SERVICE LETTER

No. 532

Voltage Regulation Component Grounding

PA-23-250 (Six Place) Aztec "D"
PA-30 Twin Comanche "C"
PA-31 and PA-31-300 Navajo

This Sketch represents the Aztec "D" Voltage Regulation Component Grounding Modification, and is similar to the modification required for affected PA-30 and PA-31 aircraft.

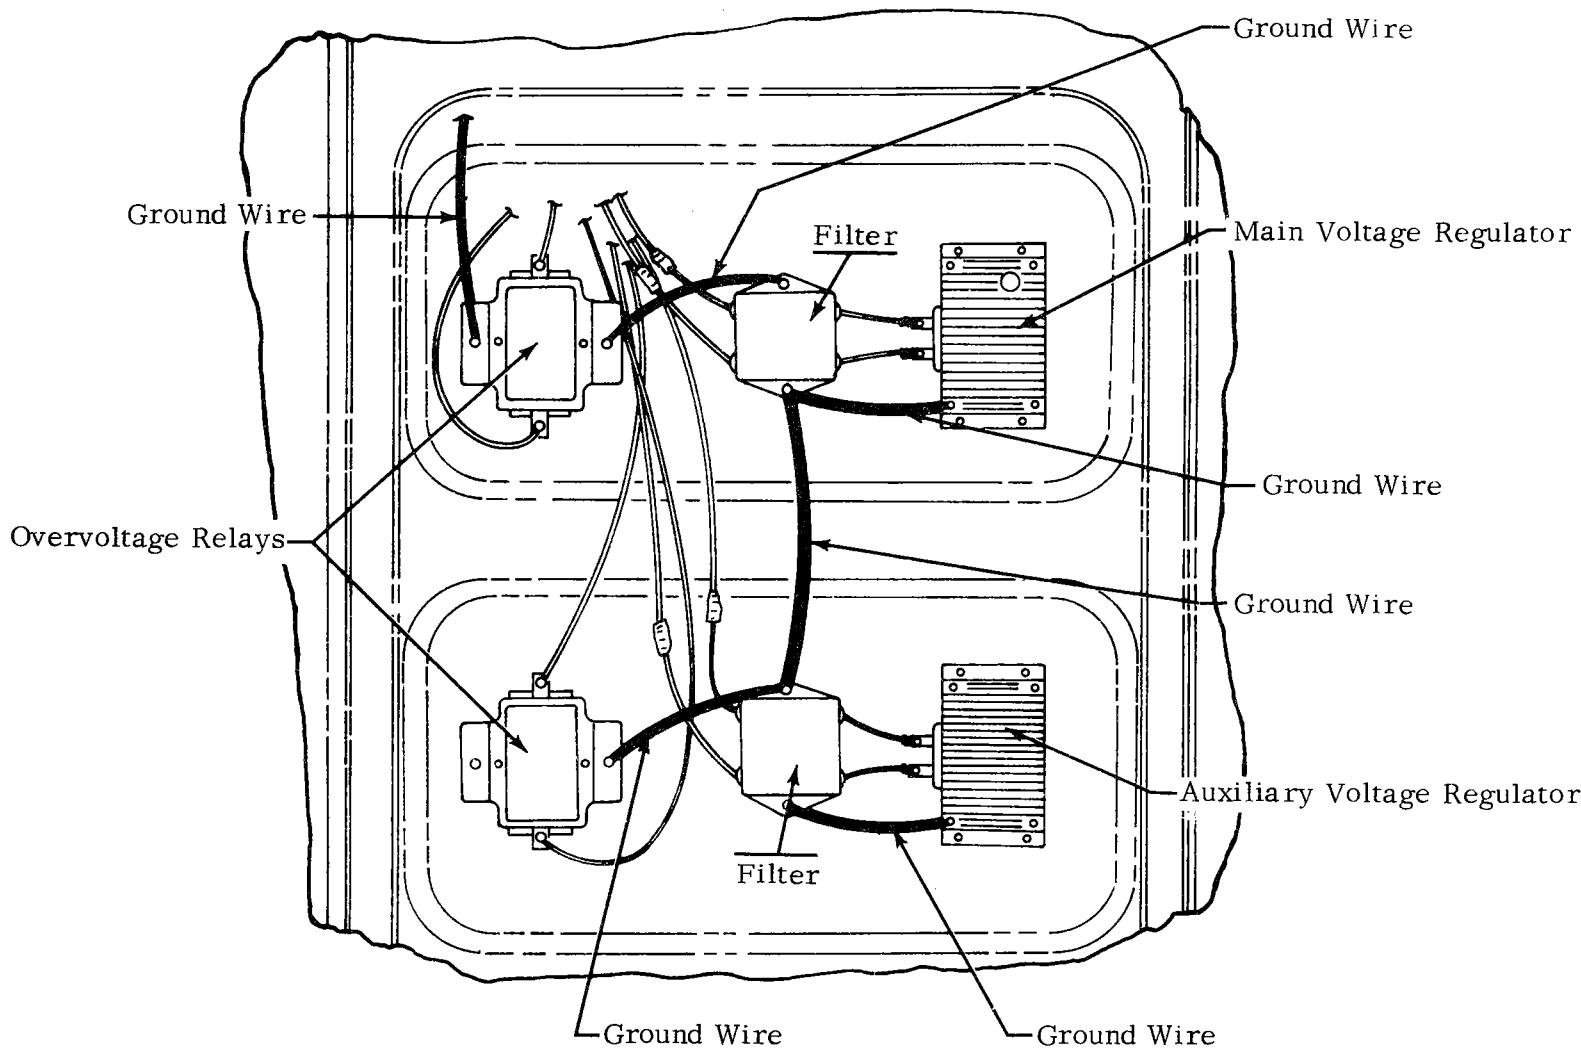
To provide a supplemental method of grounding the aircraft
voltage regulation system components to the aircraft structure.
See sketch attached to this letter for general information.

Detailed Sketches relative to the above referenced aircraft are contained in the applicable Voltage Regulation Component Installation Kits, specified on the Service Letter.
